## John Phillpott - Fwd: Public Comment in relation to Vincentia Coastal Village Project Approval; Modification 9 (number 06 0058 Mod9)

Section 75W Modification of Concept Plan Approval (MP06\_0060) and Project Approval (MP06\_0058) – Modification No. 9

Vincentia Coastal Village & District Centre, Corner of Wool Road and Naval College Road, Vincentia – Western and Central Villages

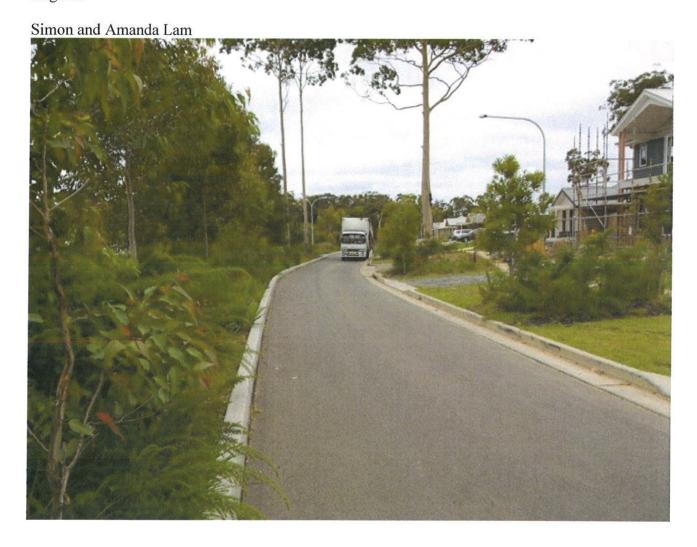
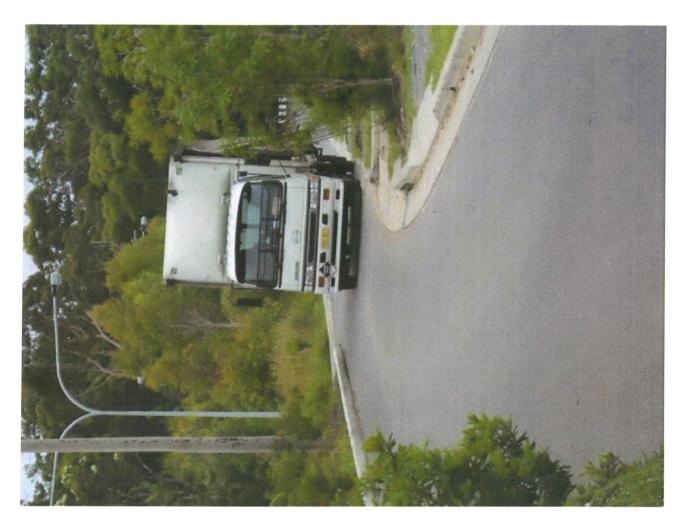
I am not sure where the update on Modification 9 sits and I am not sure whether or not these will help. The enclosed photos show what I meant by the width of the road and suitability for it being the main thoroughfare. The pictures show a parked truck which rendered the road unsuitable to pass. As such, to get to our home, my wife had to reverse, drive around the block and then up the wrong side of the road. I hope that these pictures bring some clarity to the email I sent earlier in the year. Thank you for your time.
